TRAFFIC MITIGATION: Piraeus northbound at La Costa Ave.

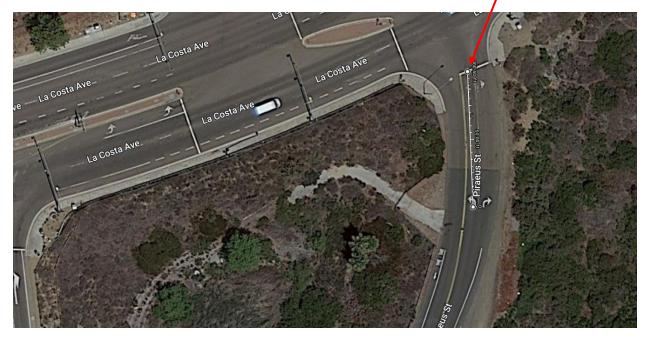
Google Maps view of Piraeus St intersection with La Costa Ave. Overlaid measuring scale shows the EXISTING approximately 100-foot-long turn lanes on Piraeus, which cause a backup queue once 4 of 5 cars are in the left turn lane.

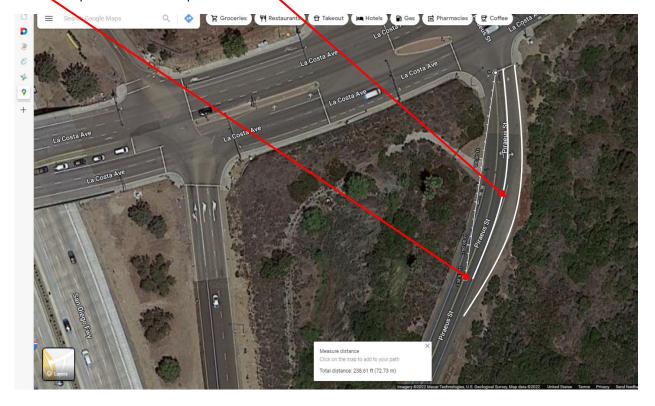
Google Maps view of Piraeus St intersection with La Costa Ave. Overlaid measuring scale and white lines shows SUGGESTED FUTURE paving of the shoulder to allow extension of the turn lanes to approximately 250 feet in length to reduce the queue that forms at peak traffic times.
